**SECTION 00 91 13**

**ADDENDUM NO. 1**

**APRIL 3, 2024**

**PROJECT:** Window & Door Replacement at  
Captains Golf Course  
1000 Freemans Way  
Brewster, MA

SKA-1

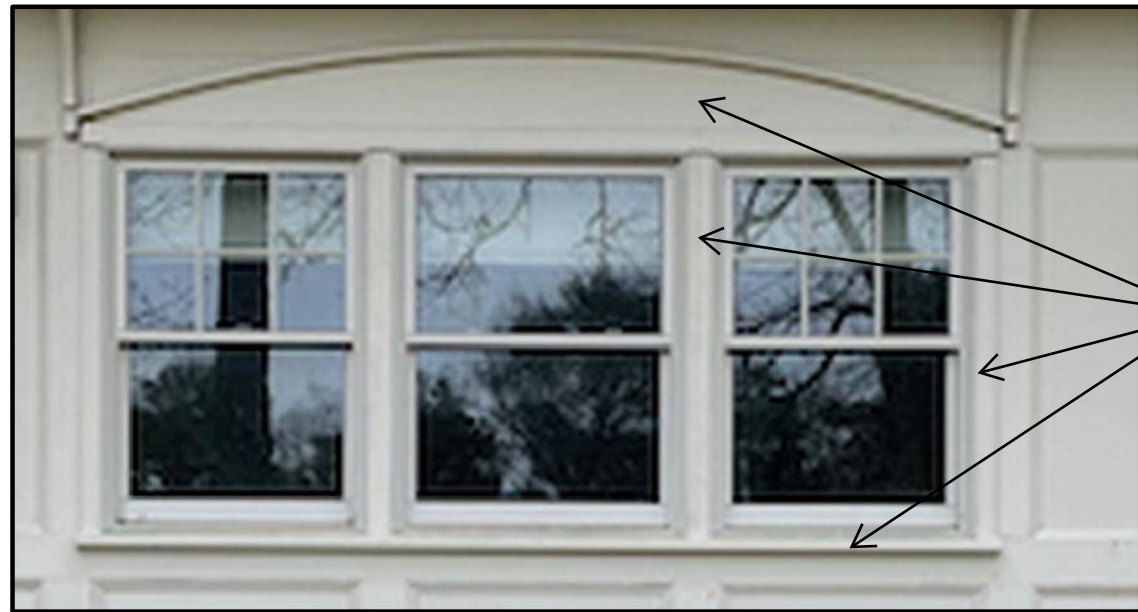
8. Question: Can the interior and exterior trim scope be defined for window elevations A, B, C and X? Following the walkthrough, the existing conditions do not match the details on A4.

PROVIDE AND INSTALL NEW WOOD TRIM TO MATCH EXISTING. IF TRIM CAN BE REMOVED WITHOUT DAMAGE, IT CAN BE REUSED. IF EXISTING TRIM DOES NOT HAVE TO BE REMOVED TO INSTALL NEW WINDOWS OR DOORS, THE TRIM DOES NOT NEED TO BE REPLACED.

PROVIDE AND INSTALL NEW WOOD TRIM TO MATCH EXISTING. IF TRIM CAN BE REMOVED WITHOUT DAMAGE, IT CAN BE REUSED. IF EXISTING TRIM DOES NOT HAVE TO BE REMOVED TO INSTALL NEW WINDOWS, THE TRIM DOES NOT NEED TO BE REPLACED.

PROVIDE AND INSTALL NEW PVC TRIM TO MATCH EXISTING. IF TRIM CAN BE REMOVED WITHOUT DAMAGE, IT CAN BE REUSED. IF EXISTING TRIM DOES NOT HAVE TO BE REMOVED TO INSTALL NEW WINDOWS OR DOORS, THE TRIM DOES NOT NEED TO BE REPLACED.

Response: See attached drawing SKA-1 for information.
9. Question: Can the interior painting scope be defined. Note 1 on A4 states "Paint all new trim and disturbed existing materials." Is the scope to only cut in new paint color around new trim? Or is it to paint the entire wall? Please advise.
